MALT IDE - PCB V1.1 PATCH

Patch 1

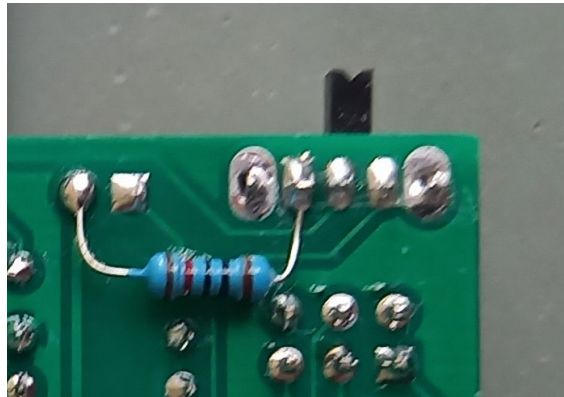
The patch prevents a reboot of the MSX machine if the ROM enable/disable switch is toggled while the machine is on.

1. Cut the trace between the switch pin 1 and the LED +5V pin at the front side of the PCB
2. Solder a 10K resistor between switch pin 1 and the LED +5V pin at the back side of the PCB
